Proposal for amendments of Regulation No. 29 (Cabs of commercial vehicles)

Submitted by the expert from Germany

The text reproduced below was prepared by the expert from Germany. It introduces amendments to Regulation No. 29 (Cabs of commercial vehicles). The modifications to the existing text of the UN Regulation are marked in bold for new or strikethrough for deleted characters.

Figure 1 - Front impact test **and front pillars impact test**
The cab is mounted on the vehicle

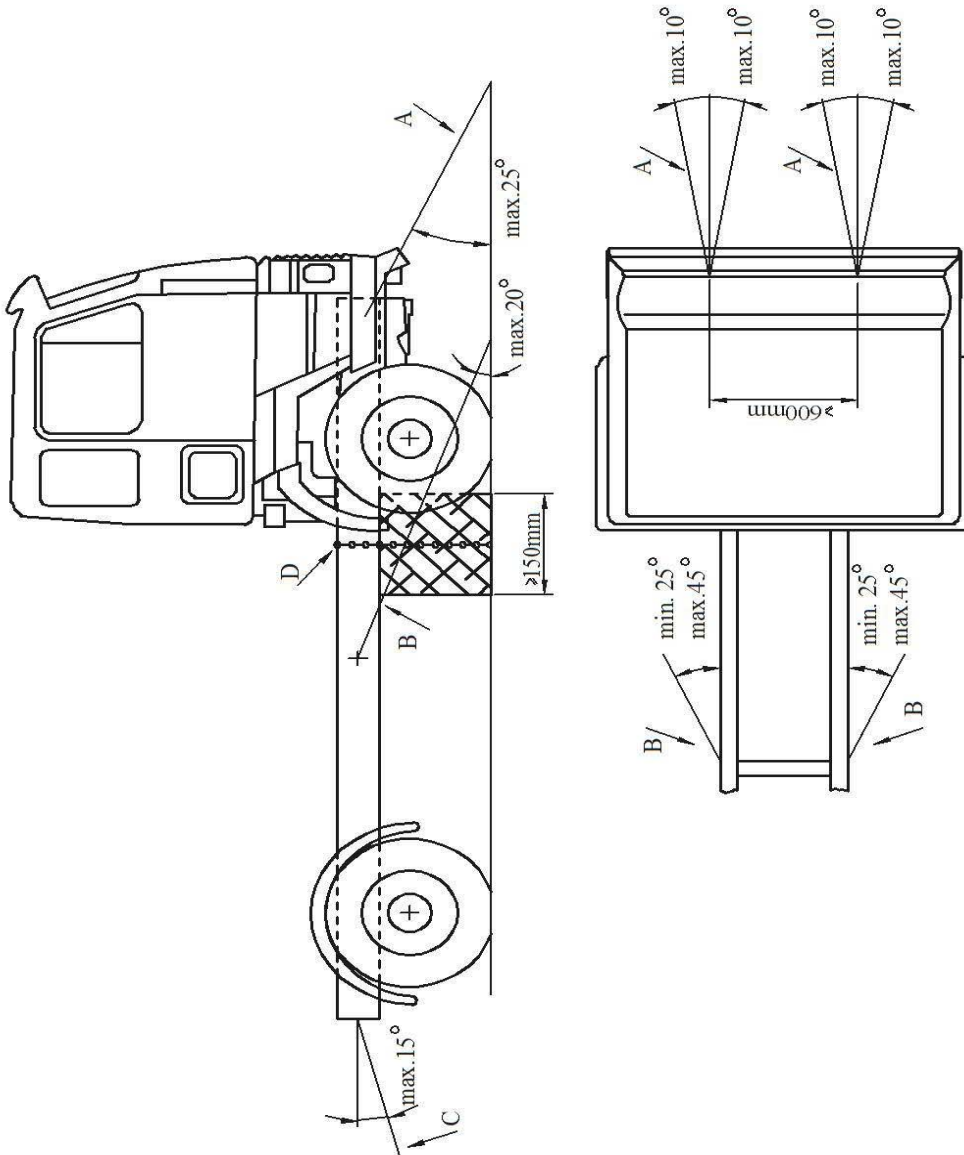
Lateral movement shall be limited by chains or ropes B attached to the chassis frame symmetrically in relation to its longitudinal axis. The points of attachment to the chassis shall be not more than 5 m and not less than 3 m from the front of the vehicle. The chains or ropes shall when tensioned form a downward angle of not more than 20° with the horizontal and their projection on a horizontal plane shall form an angle of not less than 25° and not more than 45° with the longitudinal axis of the vehicle (see figure 1 below).

Lateral movement shall be limited by chains or ropes B attached to the chassis frame symmetrically in relation to its longitudinal axis. The points of attachment to the chassis shall be not more than 5 m and not less than 3 m from the front of the vehicle. The chains or ropes shall when tensioned form a downward angle of not more than 20° with the horizontal and their projection on a horizontal plane shall form an angle of not less than 25° and not more than 45° with the longitudinal axis of the vehicle (see figure 1 below).

The proposal also gives freedom instead of the wooden block shown in Figure 1 to use rigid composite blocks and/or (adjustable) metal brackets to make the fixation of the vehicle on the test rig more convenient.

The longitudinal members of the chassis frame shall be supported on wooden blocks, **rigid composite blocks and/or metal brackets** across their full width and over a length of not less than 150 mm. The front edges of the blocks must not be situated forward of the rearmost point of the cab, nor rearward of the mid-point of the wheel base. At the manufacturer's request the chassis frame shall be set in the attitude it takes up when loaded.

Figure 2 Roof strength test
The cab is mounted on the vehicle

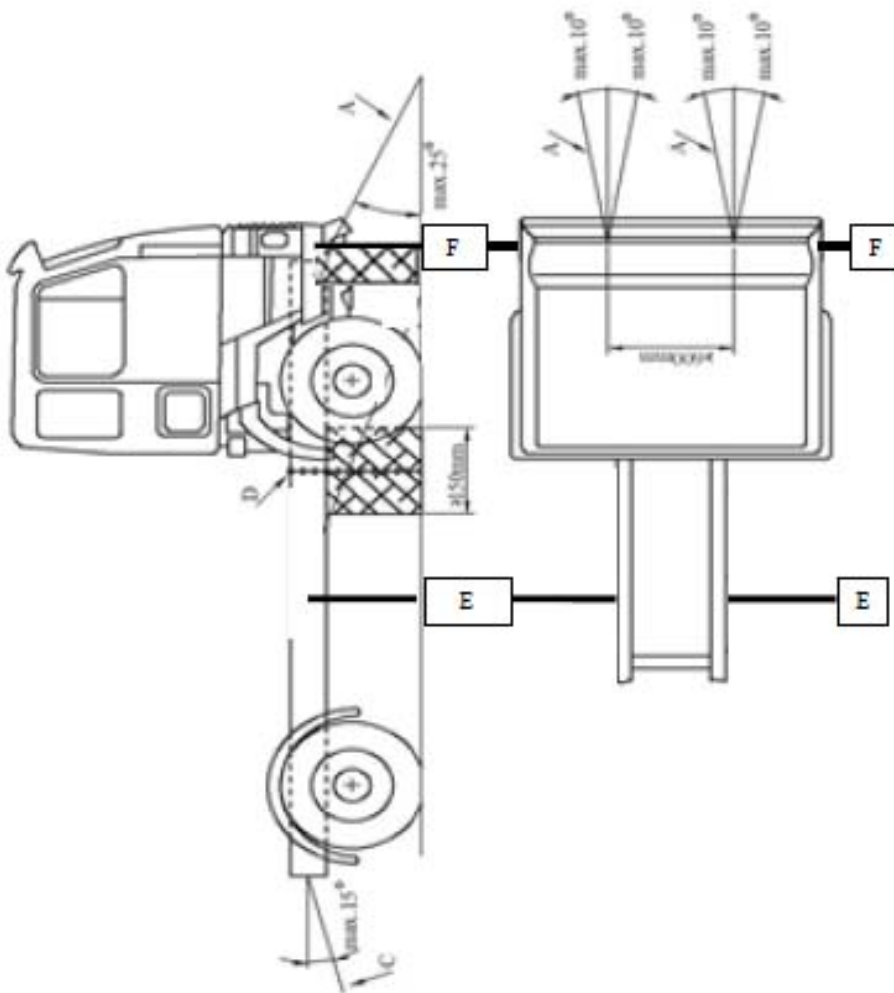
Notwithstanding paragraph 1.3 an additional support shall be placed under both sides of the longitudinal members of the chassis frame's front end.

Lateral movement shall be limited by chains or ropes E and F attached to the chassis frame symmetrically in relation to its longitudinal axis.

The points of attachment of chains or rope E to the chassis shall be not more than 5 m and not less than 3 m from the front of the vehicle.

The points of attachment of chains or rope F to the chassis shall be between the center of the front axle and the front of the vehicle.

The chains or ropes shall when tensioned form a downward angle of not more than 20° with the horizontal and their projection on a horizontal plane shall form an angle $90^{\circ} \pm 5^{\circ}$ with the longitudinal axis of the vehicle (see figure 2 below).
